Former Acton Park Depot, Ark Bryon School

planning application no.PP/2015/4977

Strategic planning application stage 1 referral

The existing and the proposed site, respectively, Source – applicant's design and access statement.

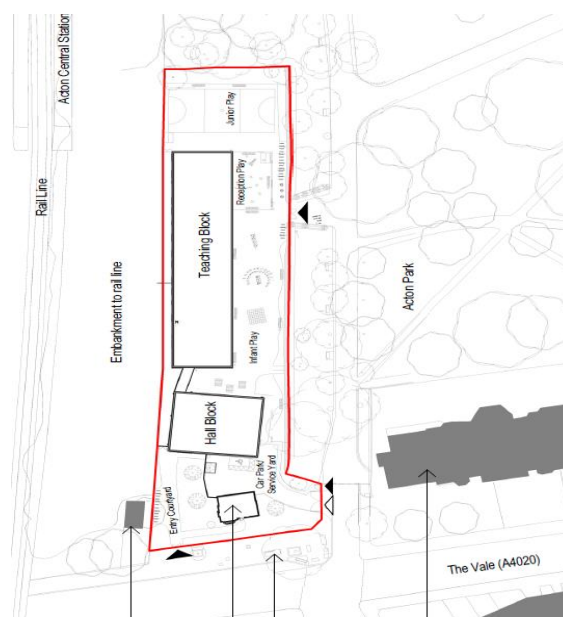
25 Impact on Openness of MOL: The footprint of the current depot buildings on the site is 437sqm. In addition there are existing metal containers across the site including some which have encroached onto land beyond the site boundary closer to the green corridor which total 170sqm. Together these existing buildings and structures amount to 607sqm of building footprint. This compares to the proposed footprint of 2,200sqm of the school. In terms of building heights, the two storey school would be higher than the existing single storey buildings at the site. Whilst the proposal represents an increase in building footprint and building heights at the site and therefore impacts on the openness of MOL in this location, in considering these impacts the following should be taken into account:

- The existing depot buildings will be consolidated into a single new school building;
- The existing buildings abut the site frontage facing the park and are clearly visible sitting adjacent to the front fence, whereas the new school building will be well set back from the site frontage and will sit neatly along the western boundary of the site, at the furthest edge of the site; and
- The containers which have encroached into land beyond the formal depot boundary (to the north-west of the site) will be removed and the original site boundary re-instated.

26 Taking these factors into account, whilst there will be impacts on the openness of the MOL, these are not considered to be severe in the context of the existing buildings and structures within the site; the siting of these; and in view of the proposed positioning of the new building. It is also relevant that the boundary of the depot site and the boundary of the proposed school site are the same therefore there is a neutral impact in this respect, as the school development would not encroach on land which is presently used as park.
